FINAL ENVIRONMENTAL IMPACT STATEMENT

MONROE COMMONS

Nininger Road
Town of Monroe, Orange County, New York

Lead Agency:
Town of Monroe Planning Board

Figure 2-5: Town of Monroe Zoning Map
 Monroe Commons
 Town of Monroe, Orange County, NY
 Source: Town of Monroe Zoning Code

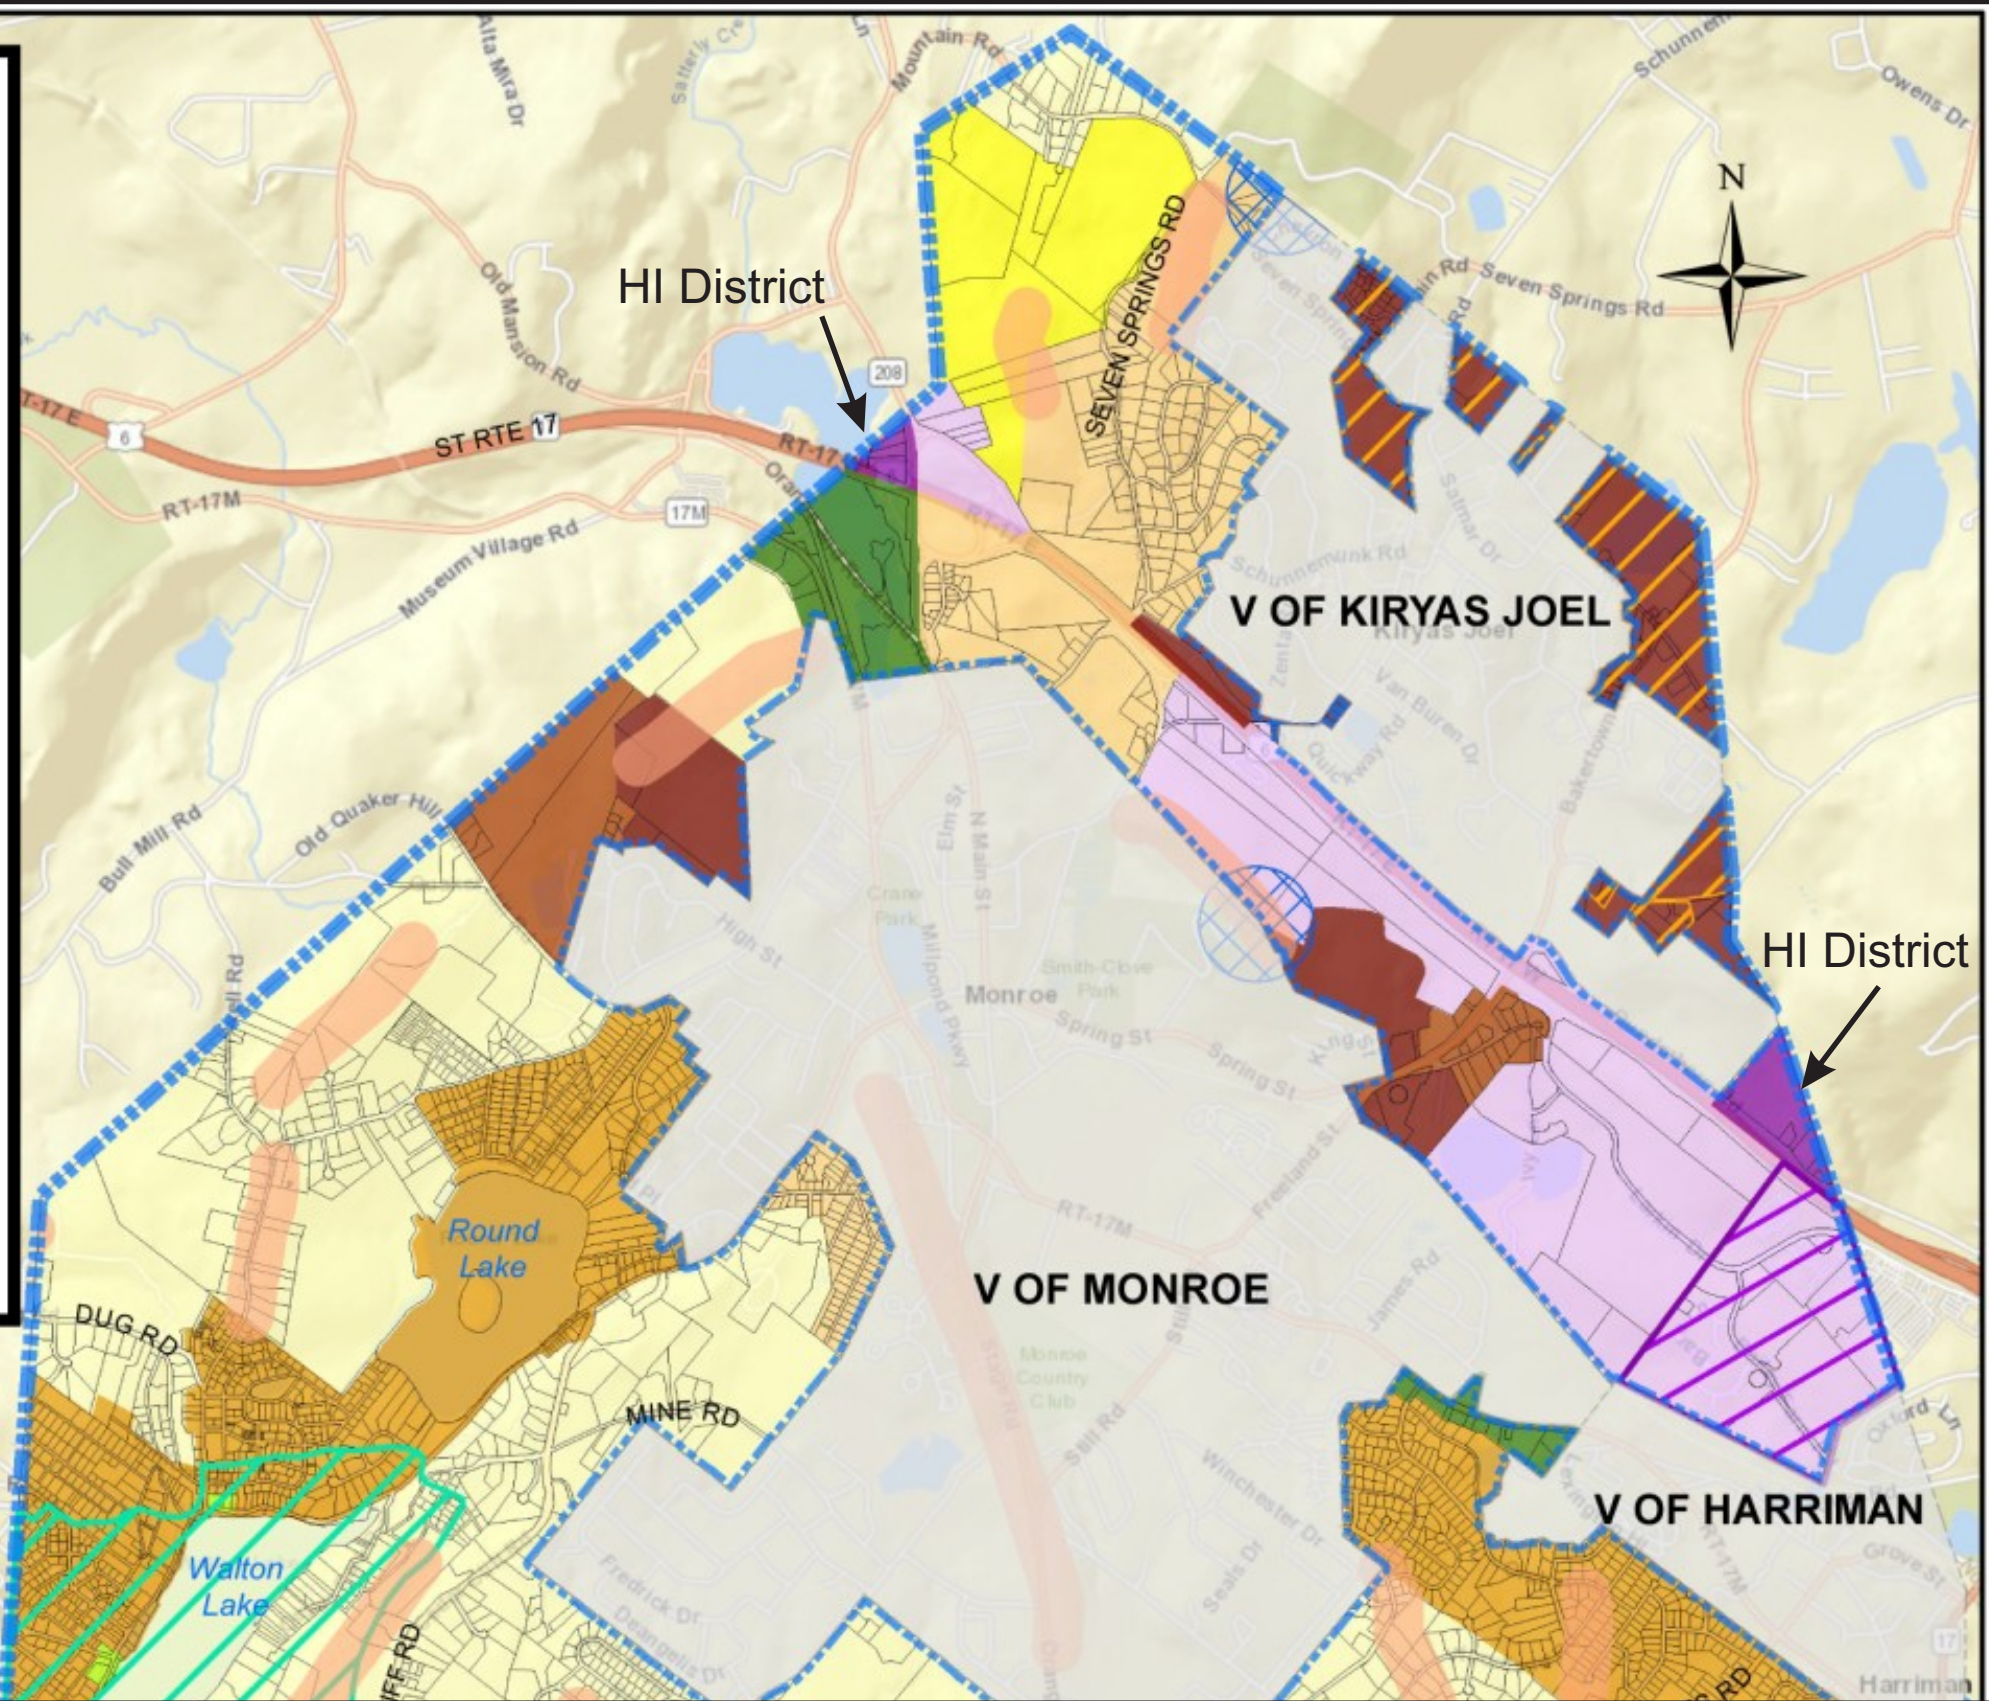
The applicant refers to "Figure 2-5" on page 2-4 of section "2.0 Description of the Proposed Action," subsection "2.2 Project Site/Environmental Setting." However, this figure is not provided. Thus, the applicant should provide this figure.

Response 2-75: *Figure 2-5 is provided at the end of this Chapter.*

Figure 5-2: Existing Ecological Communities and Ephemeral Stream Map
 Monroe Commons
 Town of Monroe, Orange County, New York
 Source: Pietrzak & Pfau Engineering and Surveying, PLLC and North Country Ecological Services, Inc.

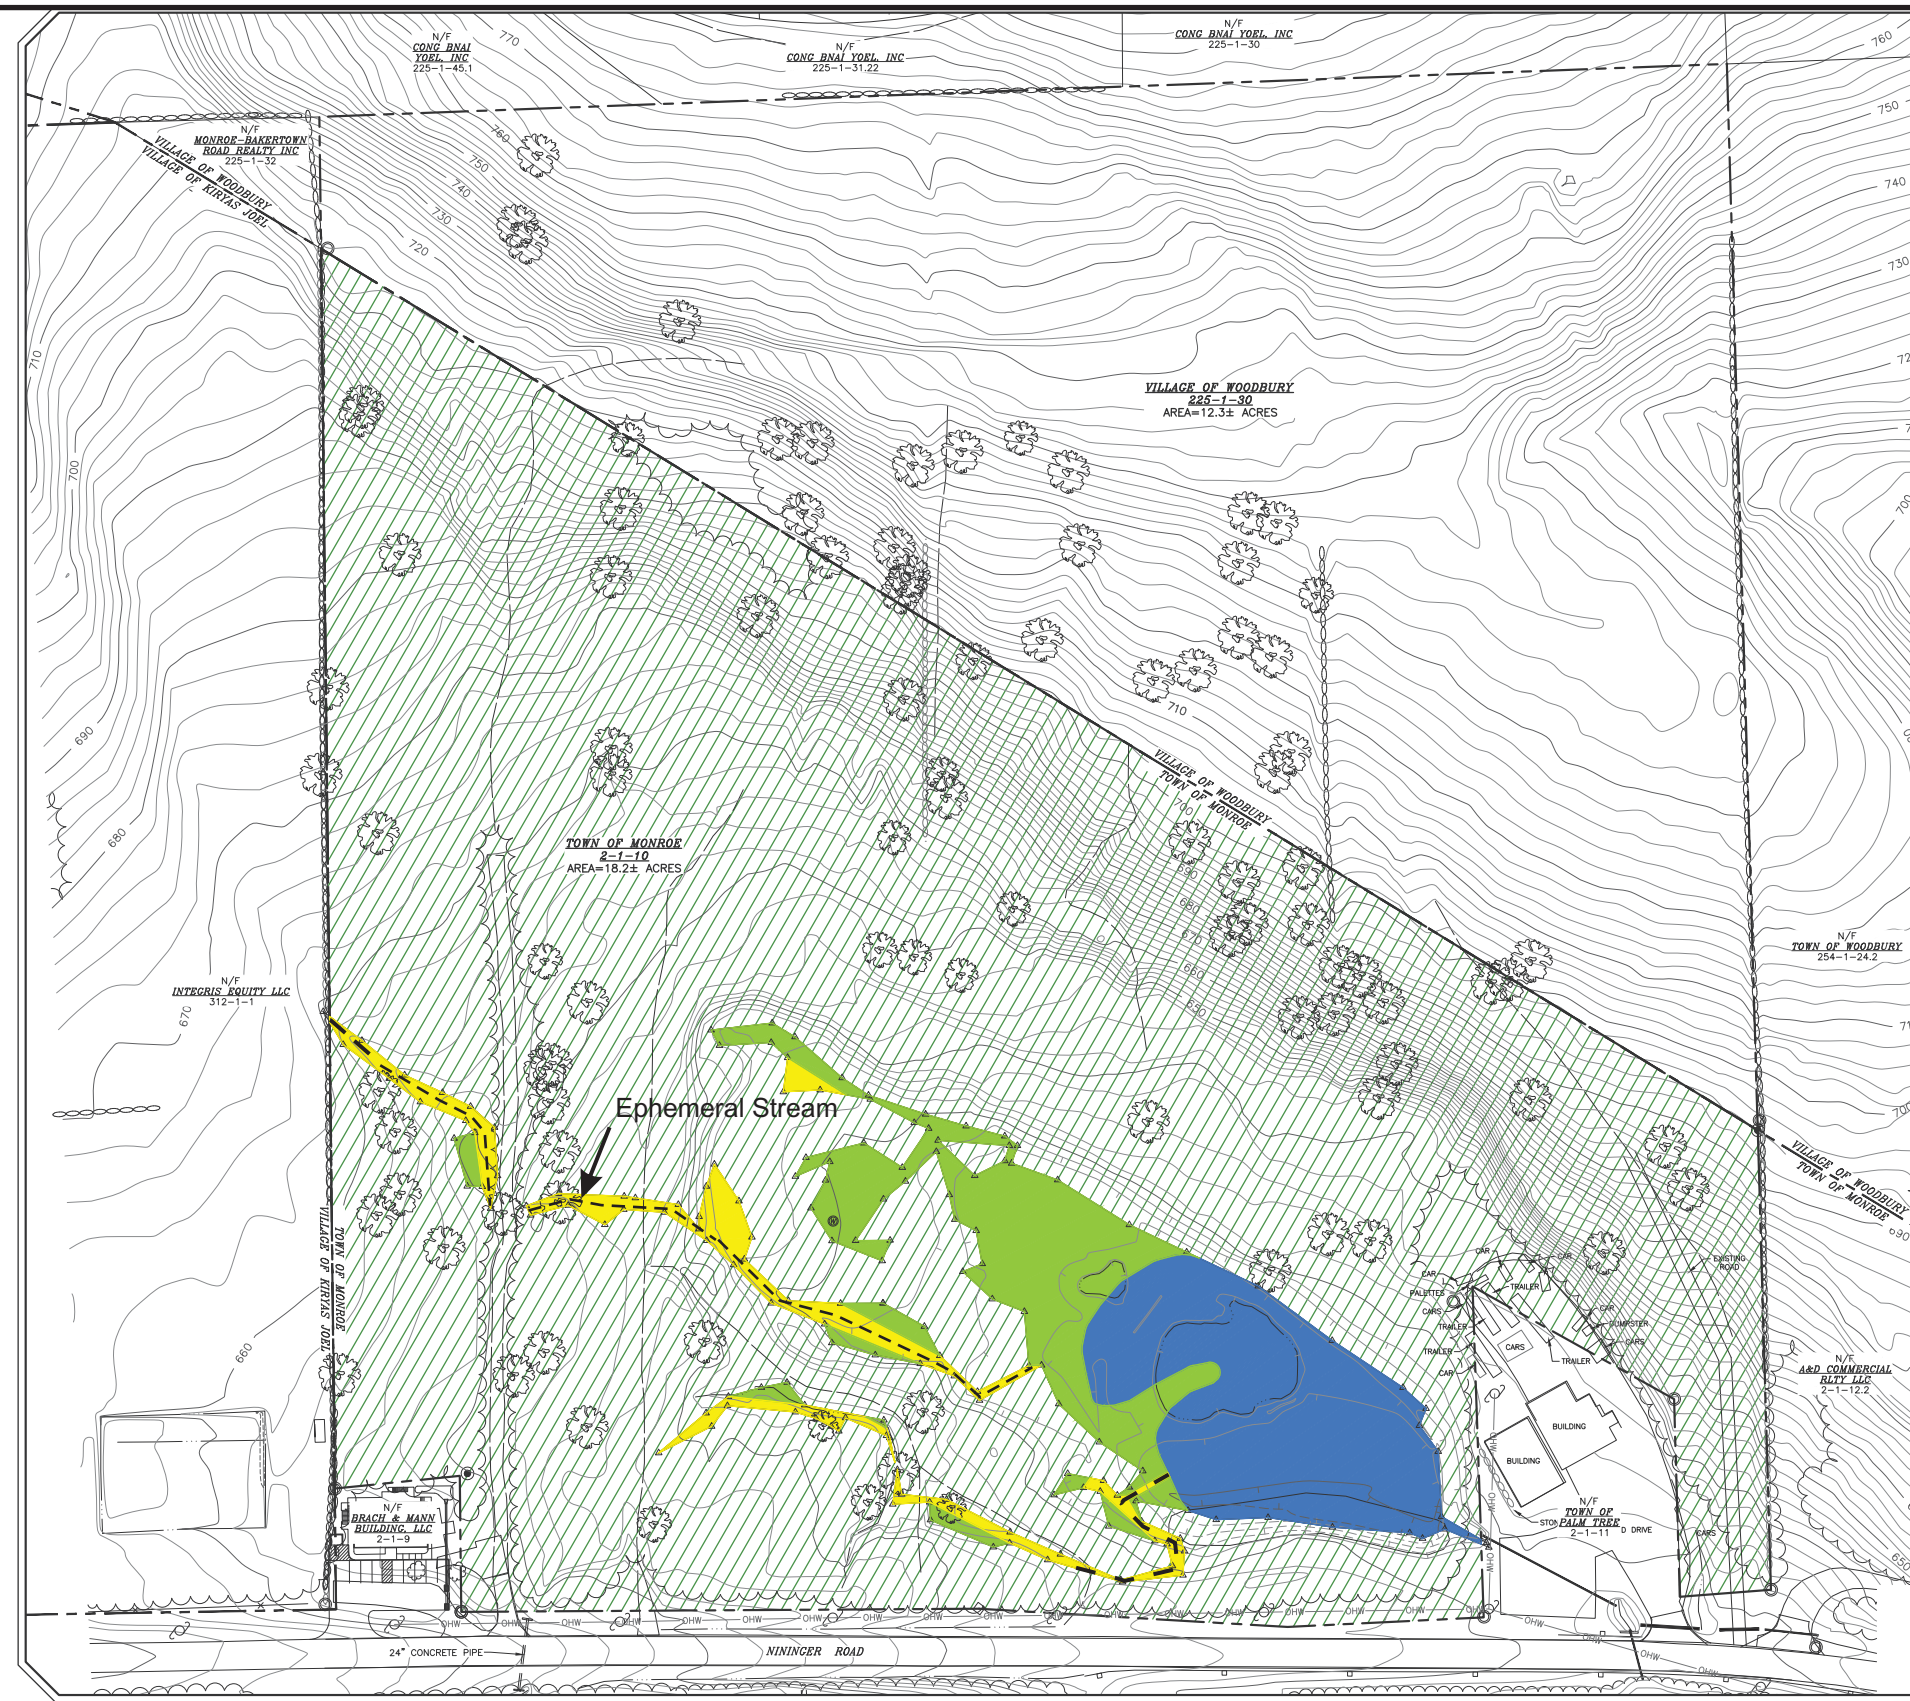
It is noted that, per request of the Planning Board’s consultants, a fourth water sample will be collected at an intermittent stream located near the project entrance, as shown on Figure 5-2. An attempt was made on June 13, 2023, but the stream was dry. Has the applicant collected the requested water sample to satisfy the Planning Board’s consultant’s request, or has it been determined that the samples collected at Sample Locations 2 and 3 on June 13, 2023, satisfy their request? Please provide any documentation of the fourth sampling and analytical data for review.

Response 5-2: See Response 5-1 above. At the time of the delineation and report, the on-site stream was designated by the DEC as a Class D stream. Since then, the DEC has reclassified many streams throughout New York State and this stream was reclassified as a Class C stream. Pursuant to Article 15 Protection of Waters regulations, a Class C stream is not protected under Article 15 and a DEC Article 15 permit is not required for disturbance to the stream. Figure 3 - DEC Mapped Aquatic Resources graphic was updated for the Pre-Construction Notification (PCN) Nationwide Permit to the USACE and 401 Water Quality Certification that was submitted to the DEC. The PCN clearly recognized the stream as a Class C stream. NCES shows on Figure 5-2, the classification, and the approximate location of that stream, based on the field evaluations (see Figure 5-2).

Response 5-5: *Location 4, near the project entrance was not identified as a stream or wetland by the NYSDEC or by the project wetland scientist, following numerous site visits (see DEIS Figure 5-2). A second set of surface water samples were collected on June 13, 2023, to provide further baseline water quality data, as described in the DEIS (see pages 5-5 and 5-6). On that date, no water was observed at Location 4, a shallow rocky channel suggested as a sampling point by the Board's consultants. Based on field observations on several dates (January 8, 2023, January 21, 2023 and June 11, 2023) the suggested sampling Location 4 infrequently carries water and is therefore not a representative surface water sampling location.*

Plan excerpt from CM General Plan – March 2023

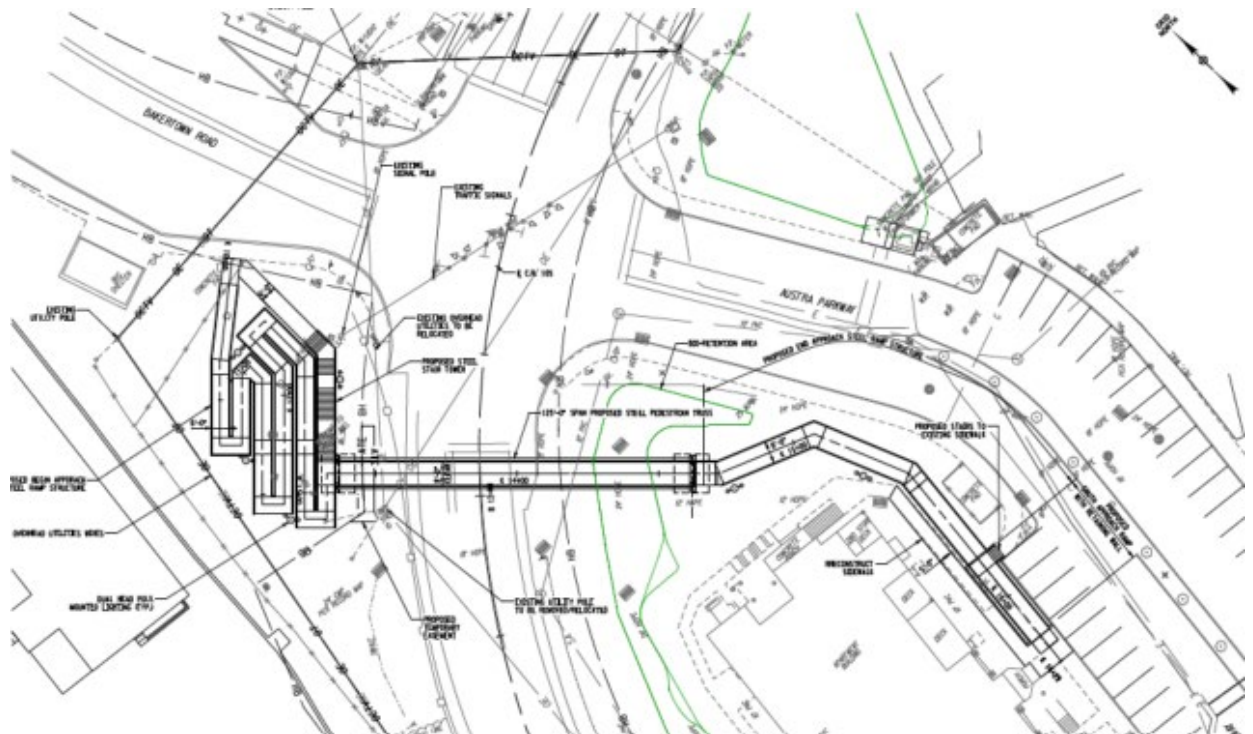
Comment 9-43 (Letter 12, James Banville, Resident, Monroe, NY December 14, 2023):

Is the pedestrian bridge over Nininger Road and Route 17 into Harriman Commons considered part of the Monroe Commons project or Moshe Gardens? The explained start time of the pedestrian bridge was quite "squishy" in the article ("... after 800 units are completed"). If it is based on contractual agreement, there must be a more definitive explanation and description for the start of the pedestrian overpass project. This endeavor makes sense to me since it will allow consumer access without the need for additional vehicles on the roadways. How many units have been completed to date? Is there a plan to cease further development of Moshe Gardens until the pedestrian bridge has been completed, or verbiage that Moshe Gardens development continues in tandem as long as significant progress is made in constructing the pedestrian bridge? Where exactly will that pedestrian bridge start and end?

***Response 9-43:** The pedestrian bridge is part of the VMG project and is due to be constructed prior to the issuance of the 801st certificate of occupancy for VMG, which is anticipated around next winter or early spring 2025. The pedestrian bridge will extend from the SW corner of CR 105/Austra Parkway to the NW corner of CR 105/Bakertown Road. See the plan excerpt below from Creighton Mannings design submission to OCDPW.*
